REMARKS

Serial No. 09/941,112

In the Drawings:

FIG. 2

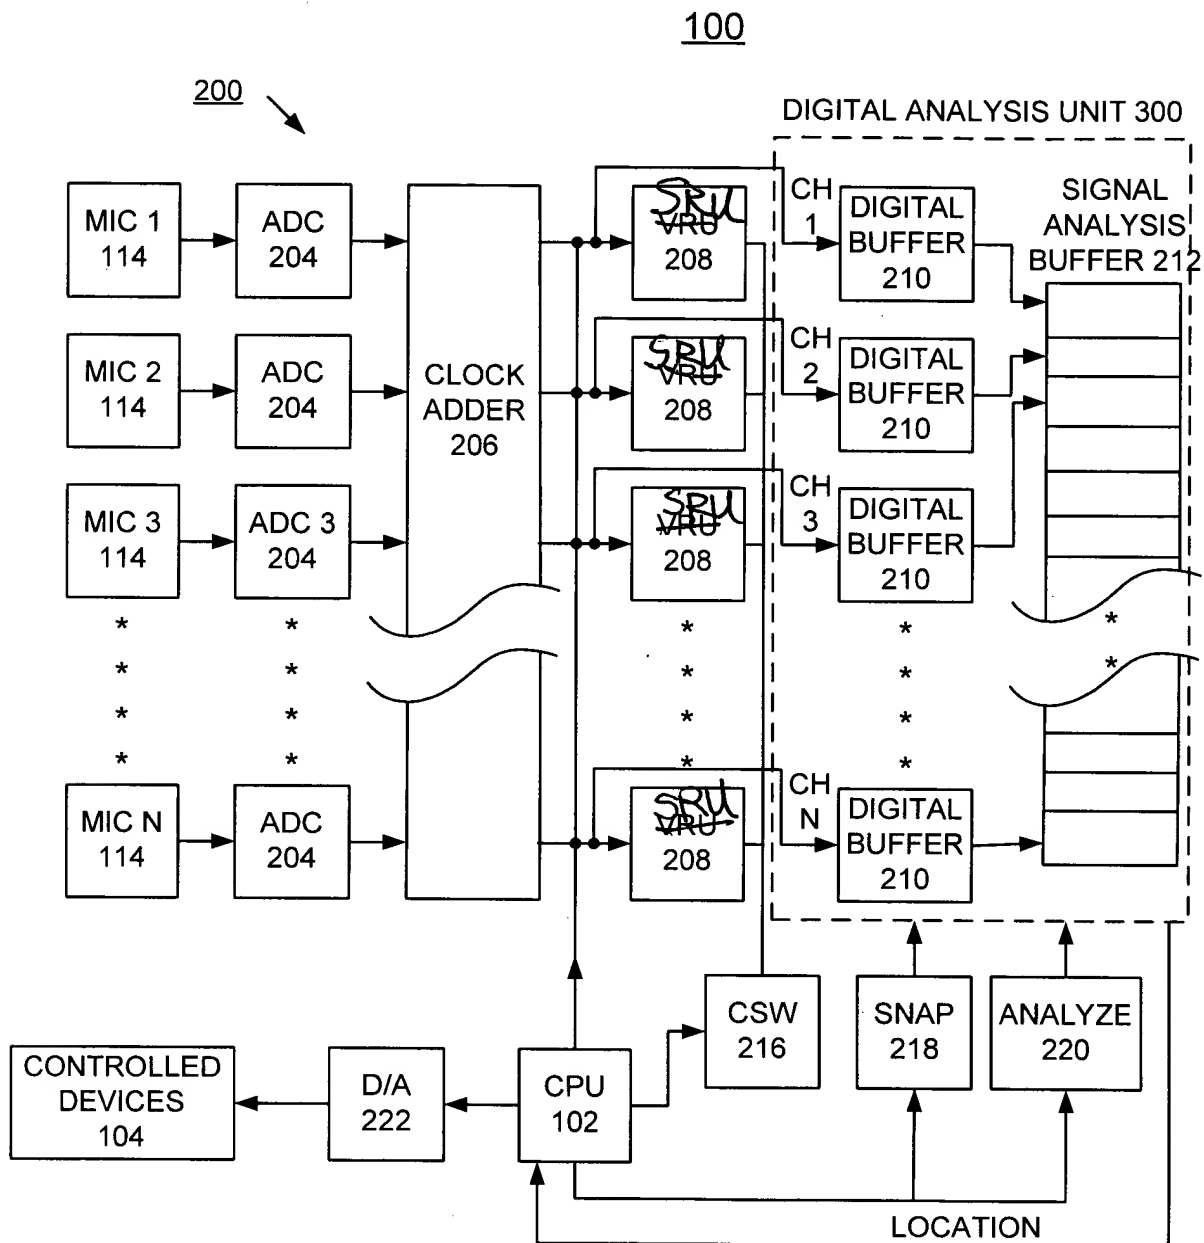
Please amend FIGS. 2 and 5 of the drawing sheets 2/6 and 5/6 to change VRU 208 to --SRU 208-- in FIG. 2 and at respective blocks 506, 508 and 510 to change "VRU" to --SRU-- and to change "VRUn" to --SRUn-- in FIG. 5. Provided as an appendix herewith is a replacement formal drawing sheet for each of the drawing sheets 2/6 and 5/6 together with a marked-up copy showing changes made in red.
